#### ADDENDUM #4

FOR  
VON RENNER ELEMENTARY SCHOOL: CLASSROOM BUILDING  
FOR  
NEWMAN-CROWS LANDING UNIFIED SCHOOL DISTRICT  
**Bid Time and Date: August 26, 2026 at 3:00 p.m.**

VON RENNER ELEMENTARY SCHOOL:  
CLASSROOM BUILDING

~~CS-0~~  
ADD 4.1

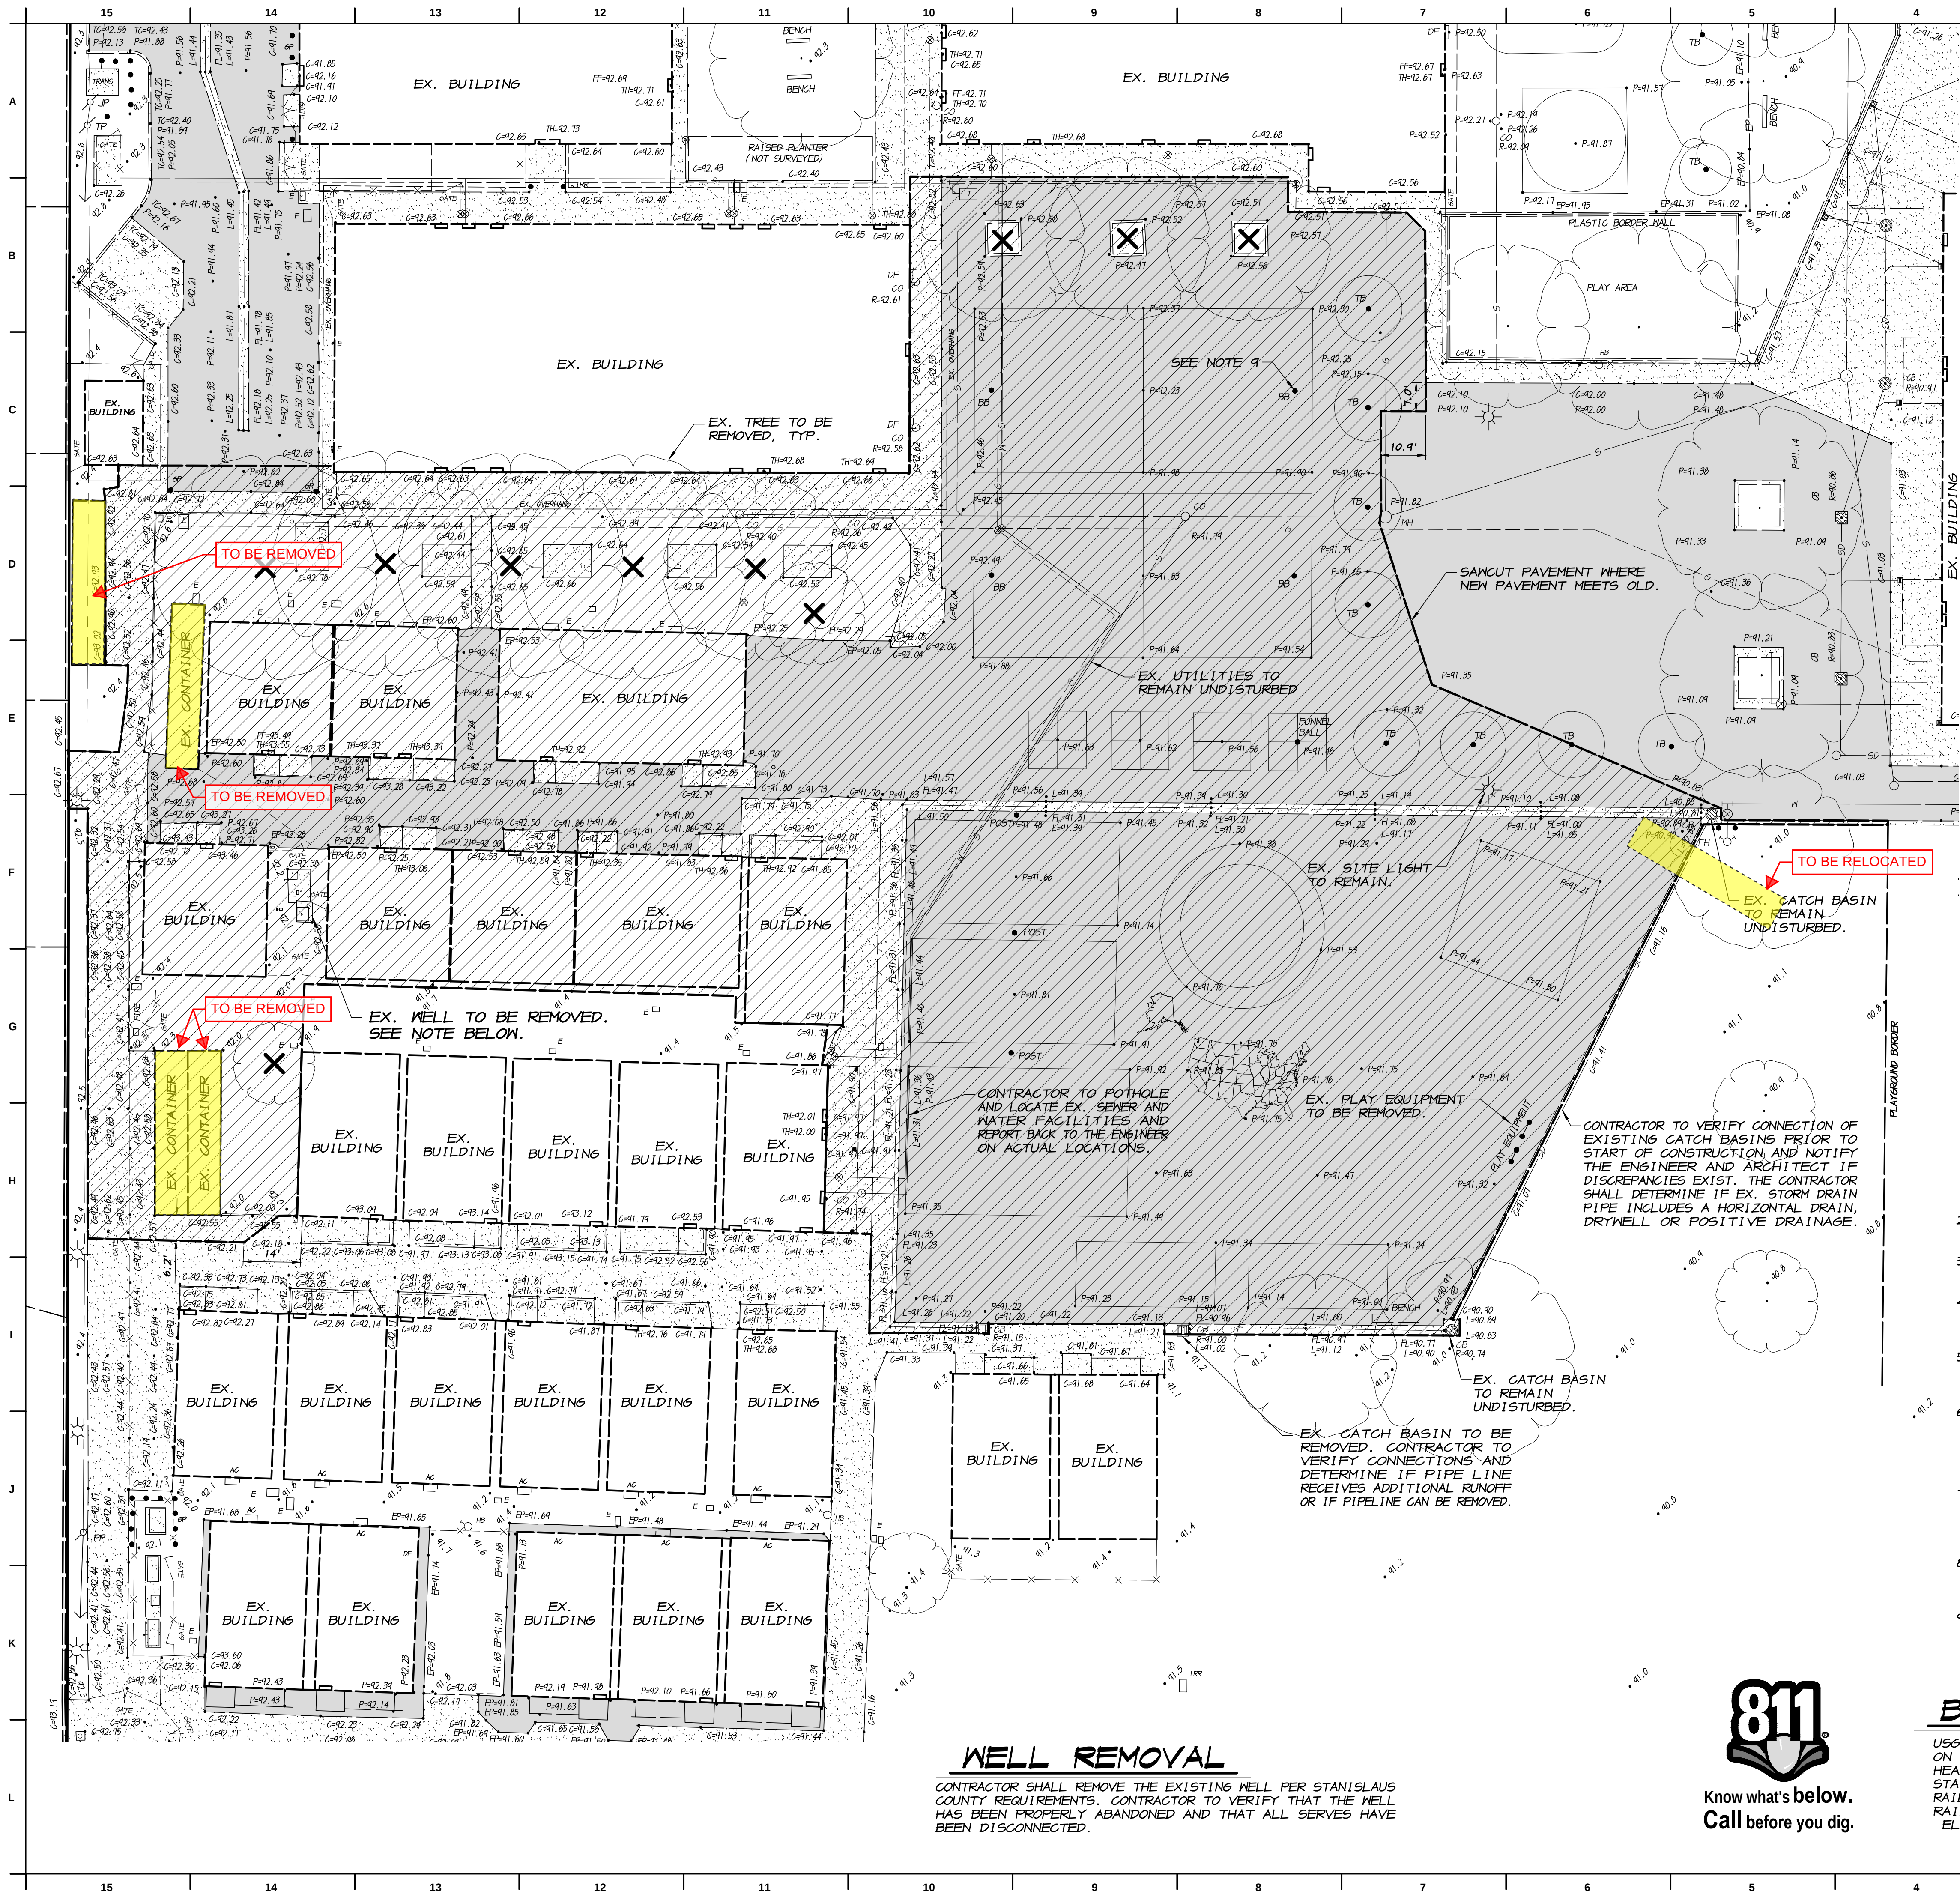
Item 001.: Reference Sheet C3.0 – Existing Metal Cargo Containers:

There (4) existing cargo containers along the western property line that are to be demolished, and one in the play court that is to be relocated out of the area of work – see attached exhibit ADD-4.1.

- Item 022: There are 3 Seatrains/Containers on site. Are these to be removed by Owner or Contractor? If Contractor, are these to be salvaged or disposed of?  
*(They will be the responsibility of the contractor, see attached exhibit ADD-4.1.)*

| DRAWING N°   | ADD_A4.2 |

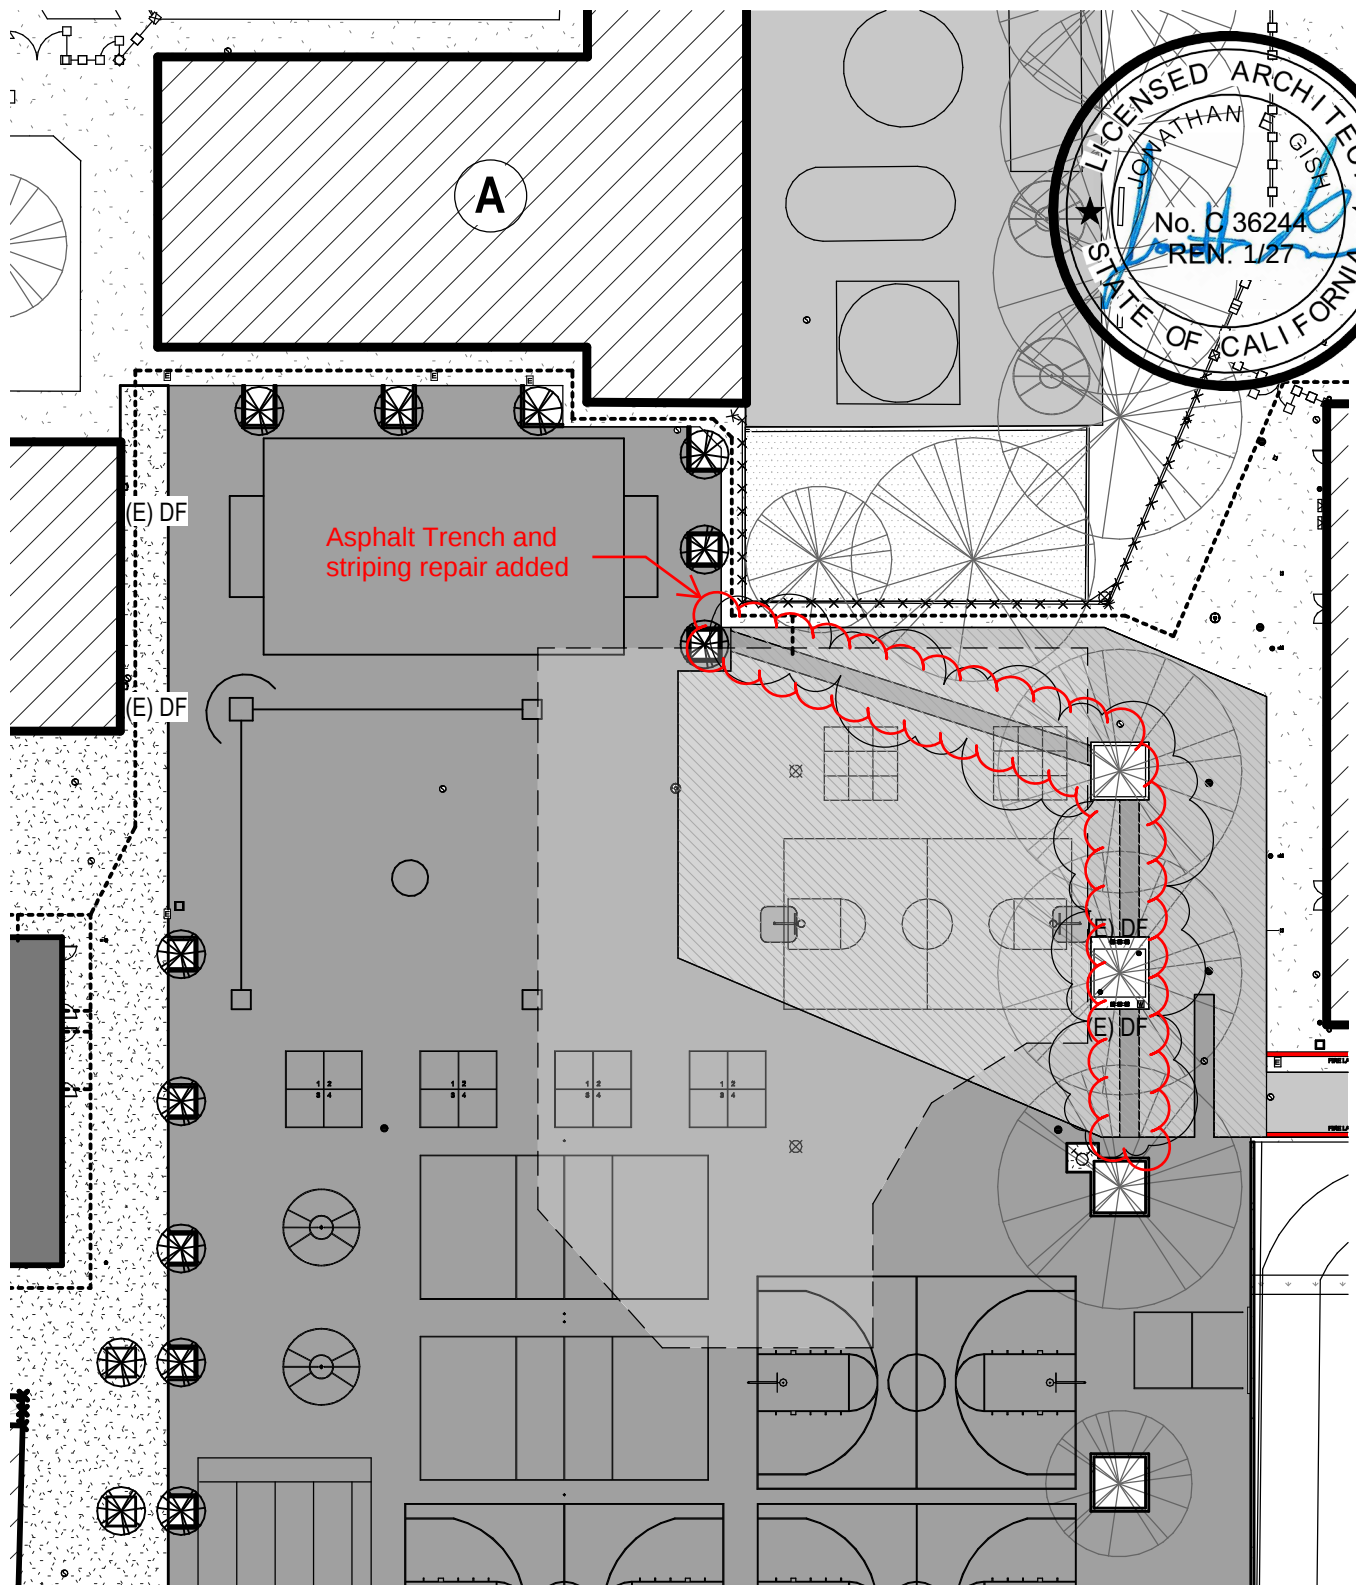
Item 005.: Reference Sheets AS-1.2 and L1.2 – New Irrigation Lines at Existing Asphalt:

Additional asphalt patching is required to accommodate the new irrigation lines – see attached exhibit ADD-4.2.
